REF: SUP25-0022
DATE: August 14, 2025

- Request - Special Use Permit for a new Community Center
- Location - 601 Junction Avenue
- Applicant / Owner - Lucas County Land Bank
One Government Center, Suite 580
Toledo, OH 43604
- Engineer - Frederick Associates
4645 N. Summit Street
Toledo, OH 43611

SPECIAL USE PERMIT
TOLEDO CITY PLAN COMMISSION
REF: SUP25-0022
DATE: August 14, 2025
TIME: 2:00 P.M.

SHEET NO.
C2.10

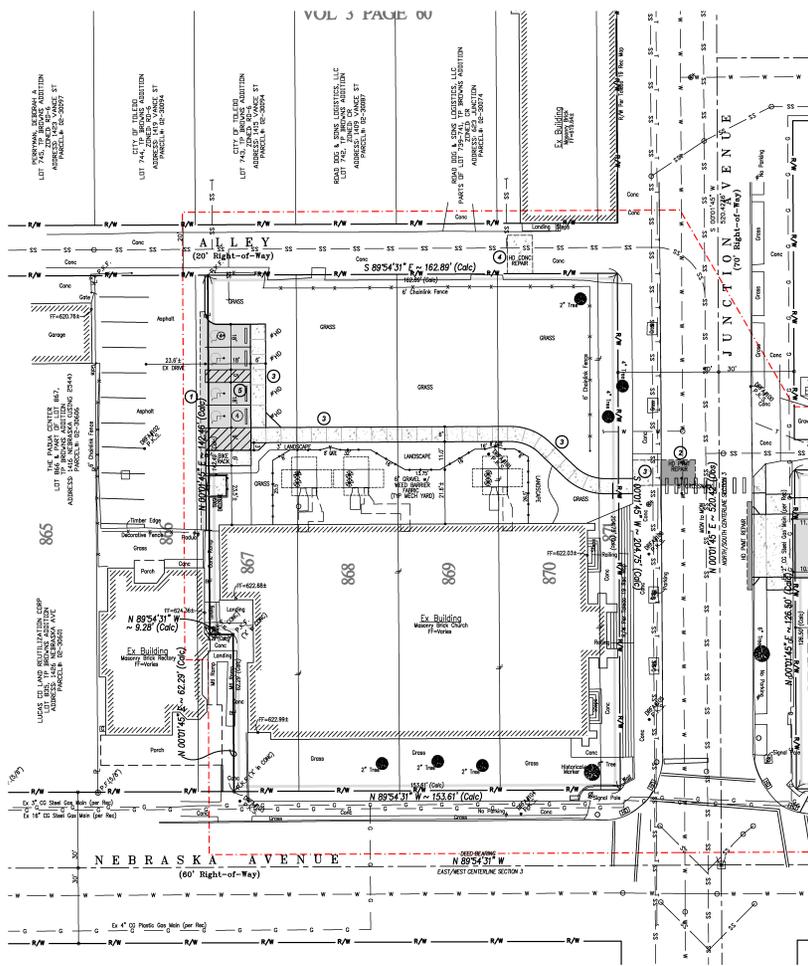
All auto accessible parking spaces must have a five foot (5’) loading aisle per TMC§1107.1702(A). One (1) of the proposed accessible spaces is missing this loading aisle. The addition of this aisle on a revised site plan has been included as a condition of approval.

5. All auto accessible parking spaces must have a 5' loading aisle per TMC 1107.1702 (A). (One auto accessible parking space does not have a loading aisle.)

6. Accessible parking signage must be posted directly in front of the parking space at a height of no less than 60 inches and no more than 72 inches above pavement level per TMC 1107.1704. (Accessible parking sign detail is too tall.)

7. All parking spaces, driveways and drive aisle must be clearly dimensioned on drawings per TMC 1107.1911. (Existing parking near new accessible parking is not dimensioned.)

8. Drive aisles are required to be 25' wide for two-way traffic per TMC 1107.1911.
9. Adjacent parking lot shall direct pedestrians to corner of Nebraska and Junction to promote utilizing signalized crossing. The mid-block crossing shall not be permitted for safety concerns of pedestrians.

10. Traffic Management will not permit Junction Avenue driveway access for the adjacent parking lot.
11. Any and all unused curb cuts and drive approaches must be removed on Junction Avenue and replaced with new curb and grass to match adjacent areas.

SHEET NO.
C2.20

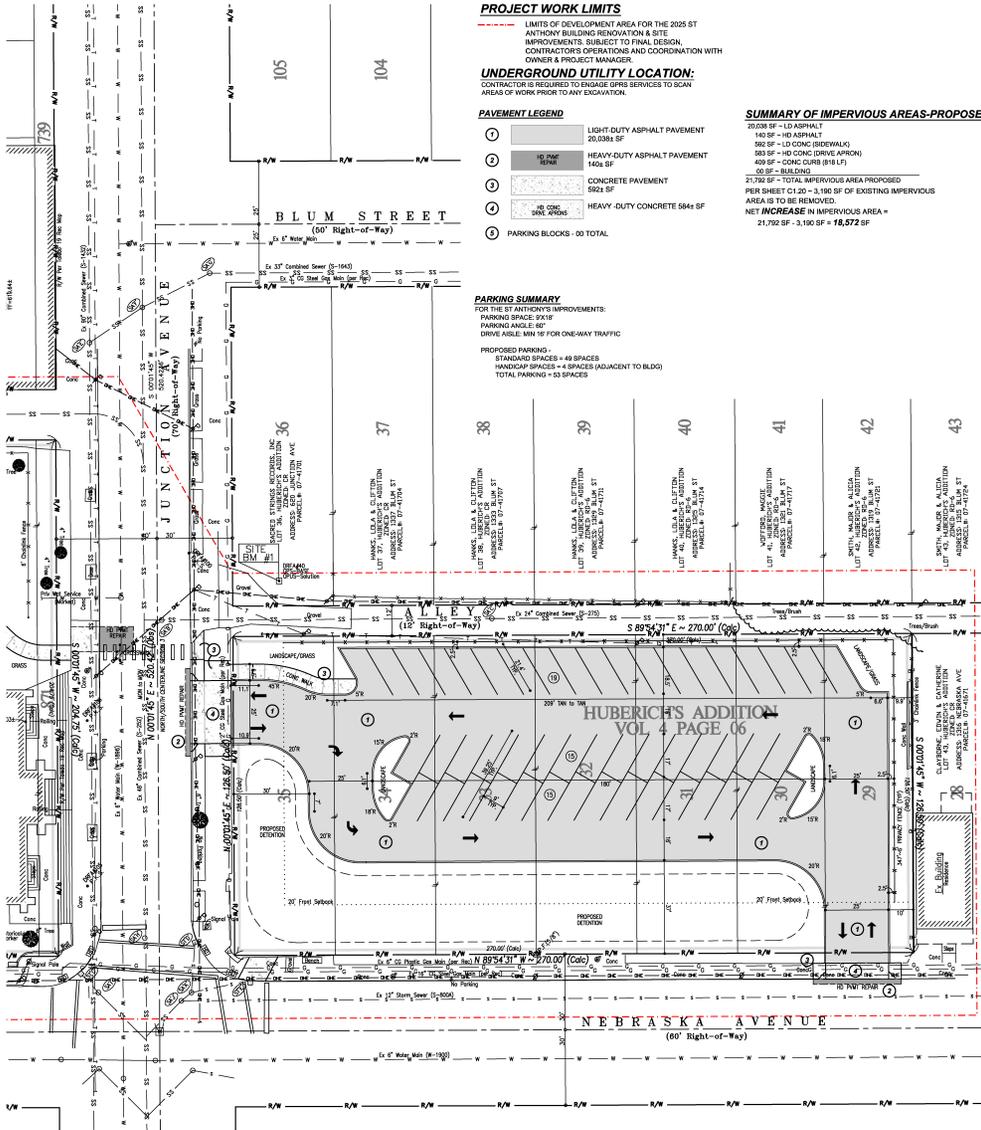
The Division of Traffic Management has objected to the proposed driveway access onto Junction Avenue and believes that effective parking lot access can be achieved solely off of Nebraska Avenue. Should access to Junction Avenue be desired, the applicant may be able to gain access via the existing alley – although they would have to improve the alley in order to do so. The removal of the proposed Junction Avenue driveway access has been included as a condition of approval. This condition goes on to permit the applicant to access the adjacent alley subject to review and approval by the Plan Director and Division of Traffic Management.

The Division of Traffic Management also objects to the proposed mid-block pedestrian crossing on Junction Avenue and asks that pedestrians be directed to the signalized crossing at the corner of Nebraska and Junction. Staff agrees that pedestrian utilization of this existing signalized crossing is preferred; however, there are concerns that the proposed detention area will naturally direct pedestrians away from this preferred crossing, leading to midblock crossings whether formalized or not. Ideally the detention area would be moved either underground or to the rear of the site; however, there would be significant cost in doing so as the site naturally drains towards the proposed detention area. Traffic Management's condition to remove the mid-block crossing has been included as a condition of approval.

SHEET TITLE
SITE
LANDSCAPE
PLAN

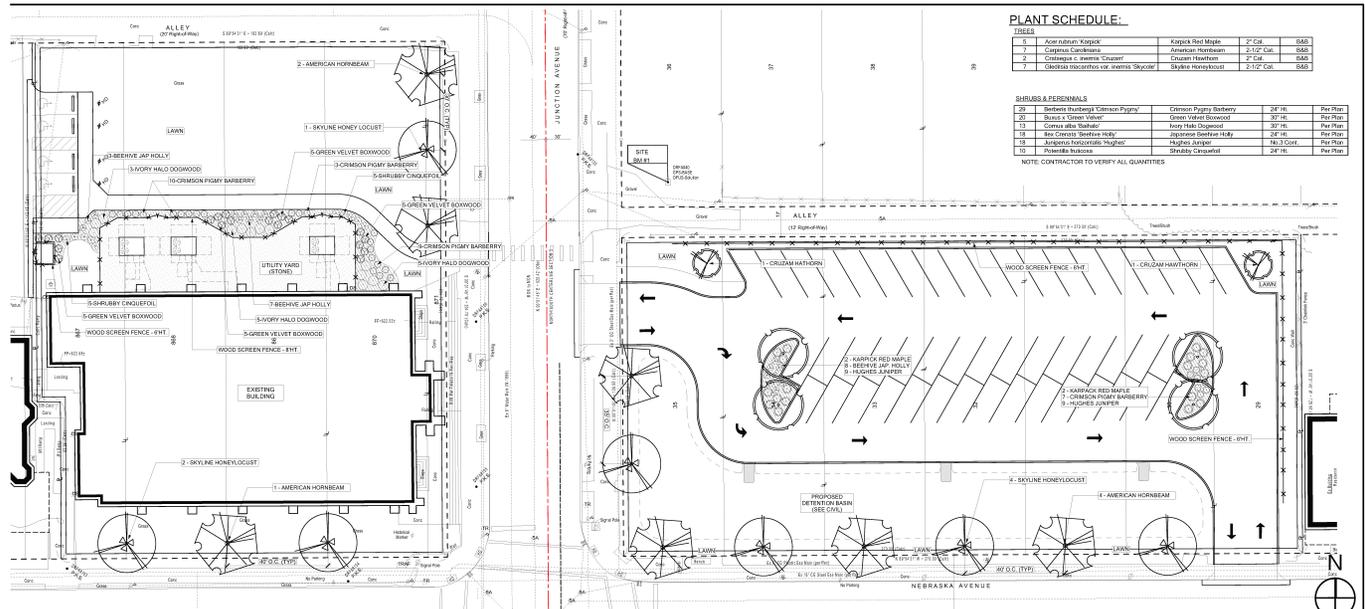
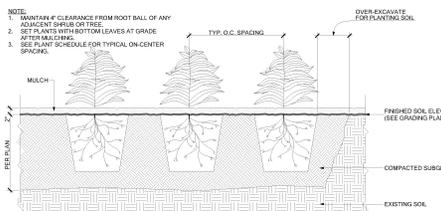
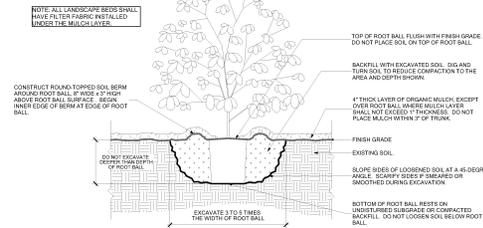
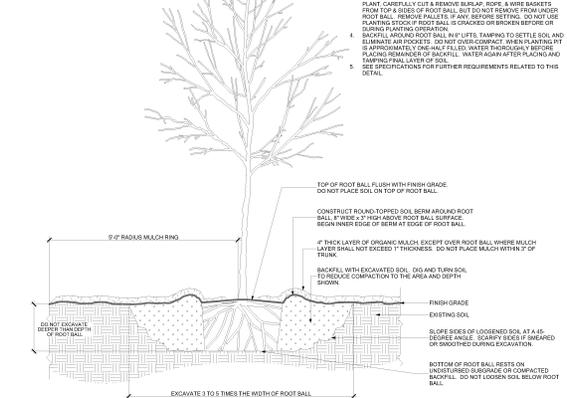
TMC§1108.0202 *Frontage Greenbelt* requires a fifteen foot (15') wide frontage greenbelt along both Junction Avenue and Nebraska Avenue. At least one (1) tree is required within these frontage greenbelts for every thirty feet (30') of frontage. Four (4) trees are required along Junction Avenue and nine (9) trees are required along Nebraska Avenue. The site plan depicts thirty-foot (30') wide frontage greenbelts with two (2) trees along Junction Avenue and six (6) trees along Nebraska Avenue. Five (5) additional trees are required within these frontage greenbelts. The addition of these required trees on a revised landscape plan has been included as a condition of approval.

TMC§1108.0202 *Frontage Greenbelt* also requires a solid evergreen hedge planting within the frontage greenbelts when abutting a parking lot. Low, undulating (horizontal and vertical) earth berms or decorative stone or brick walls (no concrete block), or ornamental metal fencing or combinations thereof may also be approved by the Planning Director. None of these options have been proposed; however, it is required in order to screen the parking lot. The addition of a frontage greenbelt screen – whether evergreen shrubs or another method approved by the Planning Director – on a revised landscape plan has been included as a condition of approval.

Lastly, TMC§1108.0202 *Frontage Greenbelt* prohibits traditional retention and detention pond stormwater treatment facilities within the required frontage greenbelt. Other stormwater treatment facilities may occupy only up to fifty percent (50%) of the frontage greenbelt. A swale stormwater treatment facility is proposed in the majority of the frontage greenbelt. A small portion of the facility – the area labeled “micropool” on the attached parking lot grading plan – is considered a traditional retention/detention pond. TMC§1108.0202 permits the Plan Director to waive these requirements if, in consultation with the City of Toledo's Division of Engineering Services, it is determined that physical site characteristics or constraints cause placement of these facilities elsewhere impractical. The Plan Director is willing to waive this requirement in this fashion so long as a portion of the stormwater facility is planted as a low maintenance pollinator garden. The submission of low maintenance pollinator garden details to the Plan Director for review and approval has been included as a condition of approval.

A Type A landscape buffer is required along the parking lot's eastern property line per TMC§1108.0203 due to the adjacent property's Duplex Residential (RD6) zoning classification. A ten foot (10') wide landscape area with a solid fence or wall with a minimum height of six feet (6') is required in this area. Four (4) trees and fifteen (15) shrubs are required for every 100 linear feet. As such, five (5) canopy trees and nineteen (19) shrubs are required within this eastern Type A buffer area. No trees or shrubs are shown on the landscaping plan within the provided ten foot (10') wide landscape buffer. The addition of these trees and shrubs on a revised landscape plan has been included as a condition of approval.

TMC§1108.0204 *Parking Lot Landscaping* requires two (2) canopy trees and six (6) shrubs for every ten (10) parking spaces within a parking lot. Ten (10) trees and thirty (30) shrubs are required in this forty-nine-space (49) parking lot. Six (6) trees and thirty-three (33) shrubs are shown on the landscaping plan. The addition of these required interior parking lot trees has been included as a condition of approval.

31. Pursuant to TMC§1108.0202 the frontage greenbelts along Junction and Nebraska Avenues adjacent to the proposed parking lot require least one (1) tree for every thirty feet (30') of frontage. **Not acceptable as depicted. A revised landscape plan shall be submitted to the Plan Director depicting at least four (4) trees within Junction Avenue greenbelt and nine (9) trees within Nebraska Avenue greenbelt.**

32. Pursuant to TMC§1108.0202 the frontage greenbelts along Junction and Nebraska Avenues adjacent to the proposed parking lot require a solid evergreen hedge planting. Low earth berms, decorative stone or brick walls, ornamental metal fencing, or combinations thereof may also be approved by the Planning Director. **Not acceptable as depicted. A revised landscape plan shall be submitted to the Plan Director depicting an acceptable screen within the Junction Avenue and Nebraska Avenue greenbelts.**

33. Portions of the proposed stormwater treatment facility shall be planted with a low maintenance pollinator garden. Low maintenance pollinator garden details shall be submitted to the Plan Director for review and approval.

34. A Type A landscape buffer is required along the parking lot's eastern property line pursuant to TMC§1108.0203. Four (4) canopy trees and fifteen (15) shrubs are required for every 100 linear feet. **Not acceptable as depicted. A revised landscape plan shall be submitted to the Plan Director depicting at least five (5) canopy trees and nineteen (19) shrubs within this type A buffer.**

35. Two (2) canopy trees and six (6) shrubs are required for every ten (10) parking spaces within the parking lot pursuant to TMC§1108.0204. **Not acceptable as depicted. A revised landscape plan shall be submitted to the Plan Director depicting at least ten (10) trees and thirty (30) shrubs within or adjacent to the parking lot.**
